Re: Victoryville 2 Hybrid Power Project: Docket No. 07-AFC-1

Enclosures: Responses to CURE Data Requests, Set Two, # 1 – 153

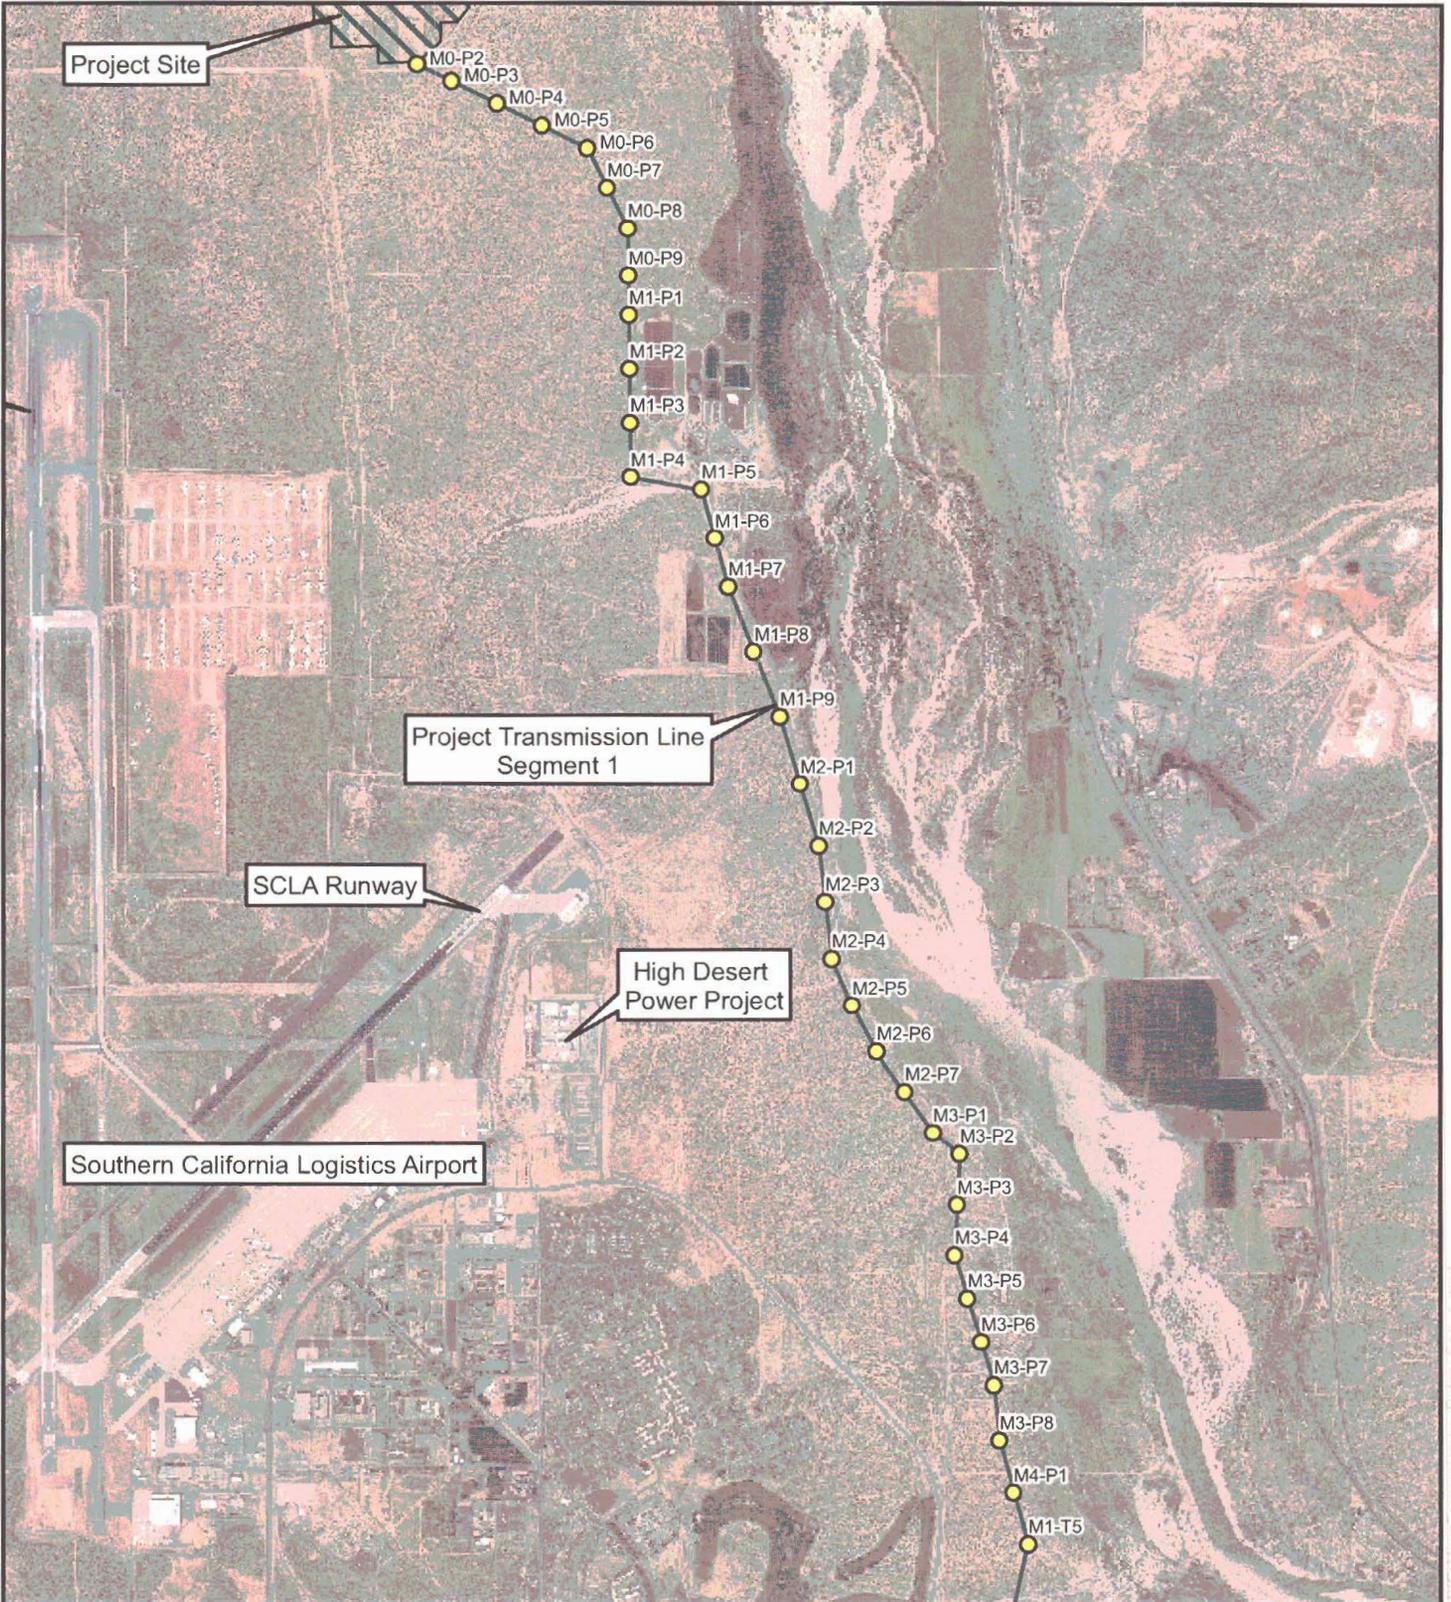
Please clarify whether the transmission lines, including construction of access roads and support structures, will impact areas of soil and groundwater contamination as identified in Figure 1, including:

Please specifically discuss whether the construction or maintenance of the lines will in any way affect the effectiveness of the groundwater cleanup that is in progress by destroying or relocating extraction wells used to pump contaminated groundwater to treatment facilities. For example, we have mapped (in green) the route of the transmission line that is depicted in AFC Figure 2-1 to be located within 500 feet of 3 extraction wells (see Figure 1, below).

Please discuss whether groundwater monitoring wells, installed to determine if contamination is present at specific locations in aquifers impacted by former operations at George AFB, will be destroyed by transmission line construction activities. For example, we have mapped (in green) the route of the transmission line that is depicted in AFC Figure 2-1 to be located within 500 feet of 10 groundwater monitoring wells (Figure 1).

Subsequent to preparation of the Phase 1 Environmental Site Assessment (ESA), the route of Segment 1 of the VV2 Project transmission line was modified. The transmission line route shown in green on Figure 1 of the CURE Data Requests Set 2 is the correct route; this route is shown throughout the remainder of the AFC and is the basis for the impact analyses presented in the AFC for waste management, as well as for all other disciplines
